APPLICATION NO.	FILING DATE	FIRST NAMED INVENTOR	ATTORNEY DOCKET NO.	CONFIRMATION NO.
10/696,791	10/30/2003	Joseph Schlegelmann	46107-0087	8130
57444	7590 04/28/2006		EXAMINER	
AUTOMOTIVE COMPONENTS HOLDINGS, LLC c/o MACMILLAN SOBANSKI & TODD			BINDA, GREGORY JOHN	
One Maritime Plaza, Fourth Floor			ART UNIT	PAPER NUMBER
720 Water Street			3679	
Toledo, OH 43604-1853			DATE MAILED: 04/28/2006

10/696,791 SCHLEGELMANN ET AL.					
Office Action Summary Examiner Art Unit					
Greg Binda 3679					
The MAILING DATE of this communication appears on the cover sheet with the correspondence address Period for Reply					
A SHORTENED STATUTORY PERIOD FOR REPLY IS SET TO EXPIRE 3 MONTH(S) OR THIRTY (30) DAYS WHICHEVER IS LONGER, FROM THE MAILING DATE OF THIS COMMUNICATION. - Extensions of time may be available under the provisions of 37 CFR 1.136(a). In no event, however, may a reply be timely filed after SIX (6) MONTHS from the mailing date of this communication. - If NO period for reply is specified above, the maximum statutory period will apply and will expire SIX (6) MONTHS from the mailing date of this communication. - Failure to reply within the set or extended period for reply will, by

Annotated Oraning Sheet

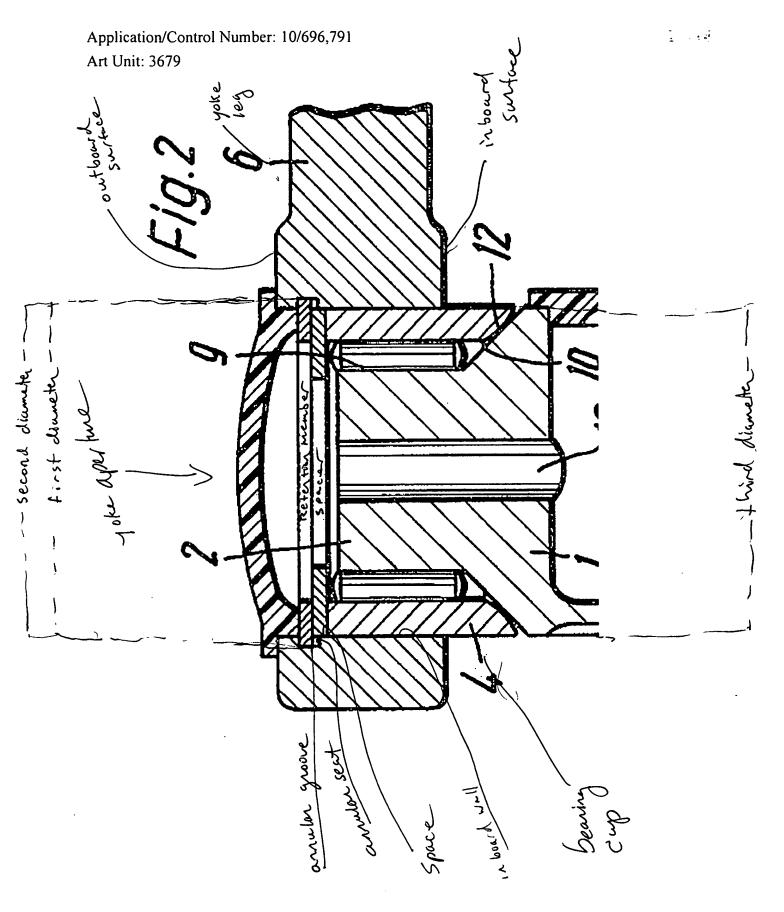
6. Claims 1 & 5-7 are rejected under 35 U.S.C. 102(b) as being anticipated by Girquis, US 3,881,324 (see particularly the attached annotated Fig. 2). Girquis shows a universal joint comprising: a yoke leg 6 with an aperture; a bearing cup 4; a retention member; and a spacer. Fig. 2 shows the aperture of the yoke leg comprises: an annular groove in which resides the retention member; a first diameter (the diameter of the portion of the annular groove occupied by the retention member); a second diameter (the diameter of the portion of the annular groove not occupied by the retention member) inboard of the first diameter; an inboard radial wall having a third diameter that is smaller than the second diameter; an annular seat (the inboard lateral surface of the annular groove); and a space below the annular seat in which resides the spacer.
